Subject: Docket Nos. 50-361 and 50-362 Amendment Applications 258 and 244 Technical Specifications Applicable to Movement of Fuel Assemblies San Onofre Nuclear Generating Station, Units 2 and 3

Pursuant to 10 CFR 50.90, Southern California Edison (SCE) hereby submits license amendment applications 258 and 244 to operating licenses NPF-10 and NPF-15 for San Onofre Units 2 and 3, respectively. Amendment Applications 258 and 244 consist of the enclosed Proposed Change Number (PCN) 593.

PCN-593

Movement of Fuel Assemblies

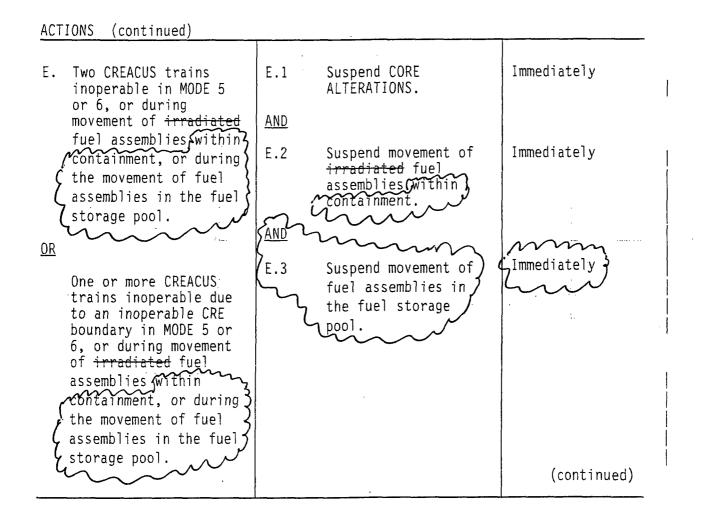
CONDITION	REC	QUIRED ACTION	COMPLETION TIME
C. Required Action and associated Completion	-	e in MODE 3.	6 hours
Time of Condition A or B not met in MODE 1, 2, 3, or 4.	AND C.2 Be	in MODE 5.	36 hours
 Required Action and associated Completion Time of Condition A not met in MODE 5 or 6, or during movement of irradiated fuel 	CR	ace OPERABLE EACUS train in ergency radiation otection mode.	Immediately
assemblies fwithin containment, or during the movement of fuel assemblies within the fuel storage pool.		spend CORE TERATIONS.	Immediately
Sun and	ir as ć ^{CO}	spend movement of radiated fuel semblies(within) ntainment.	Immediately
	کے fu th	spend movement of el assemblies in e fuel storage ol.	Immediately

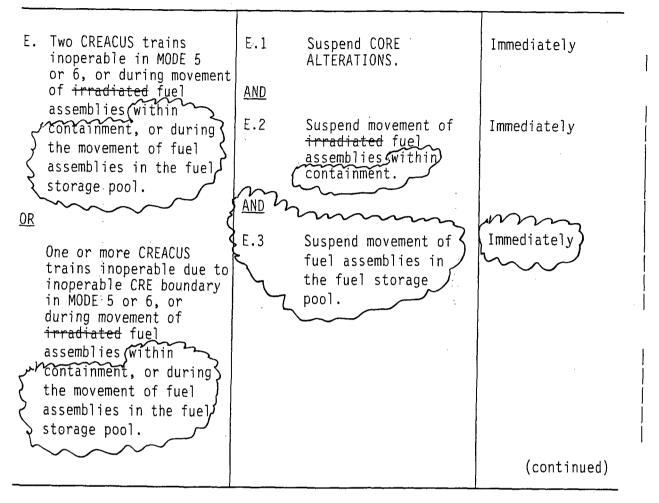
CONDITION	REQUIRED ACTION	COMPLETION TIME
C. Required Action and associated Completion Time of Condition A or	C.1 Be in MODE 3.	6 hours
B not met in MODE 1, 2, 3, or 4.	C.2 Be in MODE 5.	36 hours
D. Required Action and associated Completion Time of Condition A not met in MODE 5 or 6, or during movement of irradiated fuel	D.1 Place OPERABLE CREACUS train in emergency radiation protection mode. <u>OR</u>	Immediately
assemblies within containment, or during the movement of fuel assemblies within the fuel storage pool.	D.2.1 Suspend CORE ALTERATIONS. AND	Immediately
h	D.2.2 Suspend movement of irradiated fuel assemblies within containment.	Immediately
ć	AND D.2.3 Suspend movement of fuel assemblies in the fuel storage pool.	Immediately

AC Sources - Shutdown 3.8.2

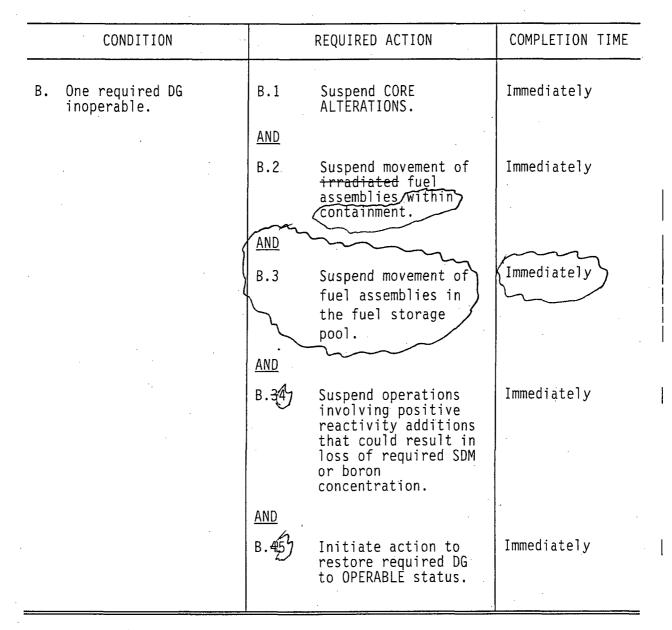
CONDITION	REQUIRED ACTION	COMPLETION TIME
A. (continued)	A.2.2 Suspend movement of irradiated fuel assemblies within containment.	Immediately
•	AND	/Immediate I w
	A.2.3 Suspend movement of fuel assemblies in the fuel storage pool.	(Immediately)
· · · · · ·	AND	
	A.2.347 Suspend operations involving positive reactivity additions that could result in loss of required SDM or boron concentration.	Immediately
	AND	
	A.2.46) Initiate action to restore required offsite power circuit to OPERABLE status.	Immediately
